SERVICE BULLETIN

M-1392A

2013-2015 HARLEY-DAVIDSON SERVICE LITERATURE UPDATE

Figure 1. 2015 FLSTNSE WSS Cable Retainer

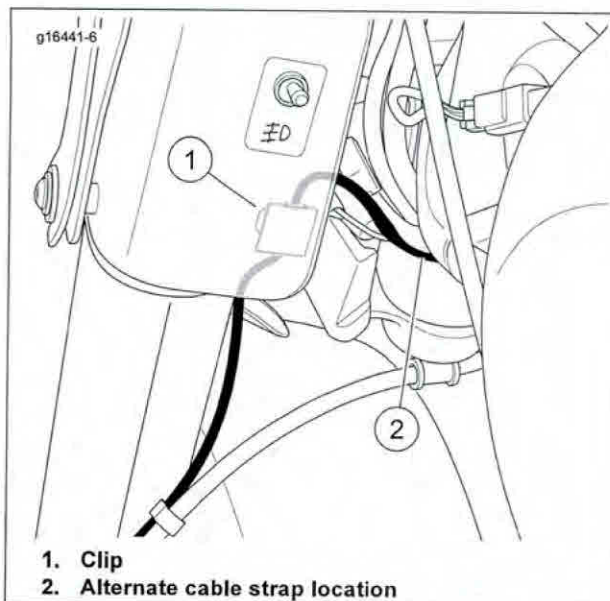
See Figure 1. As a running change, a retainer was added to the inside of the left nacelle to secure the front WSS cable.

See 7.4 WHEEL SPEED SENSOR (WSS).

- **Topic: Removal:** Change step 1 to read "Remove WSS cable from clip inside left nacelle."
- **Topic: Installation:** Change step 5 to read "Secure WSS cable to clip inside left nacelle. If clip is not present, secure WSS cable to main harness near steering head with new cable strap."
